INCH-POUND
MIL-PRF-19500/780A
w/AMENDMENT 1
26 January 2023
SUPERSEDING
MIL-PRF-19500/780A
22 February 2022

PERFORMANCE SPECIFICATION SHEET

TRANSISTOR, FIELD EFFECT RADIATION HARDENED, P-CHANNEL,
* SILICON, TYPES 2N7659, 2N7660, AND 2N7661, QUALITY LEVELS JANTXV AND JANS

* FIGURE 3. Dimensions and configuration for U3CE (SMD-0.5e), with ceramic lid.

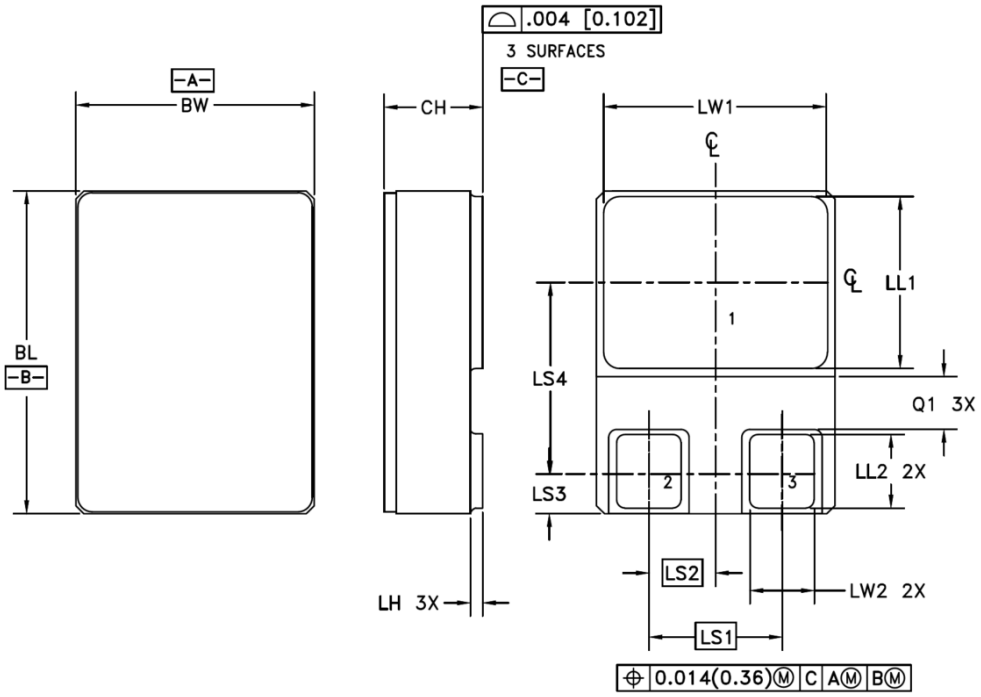
* 1.2 Package outlines. The device package outlines are as follows: TO-257AA (T3) in accordance with figure 1, a modified tab-lessTO-257AA (D5) in accordance with figure 2, and surface mount U3CE in accordance with figure 3, for all encapsulated device types.

* 3.4 Interface and physical dimensions. The interface and physical dimensions shall be as specified in MIL-PRF-19500 and on figures 1 (T3, TO-257AA with metal lid), 2 (D5, TO-257AA with metal lid and tab-less), and 3 (U3CE, surface mount similar to TO-276AA) herein.
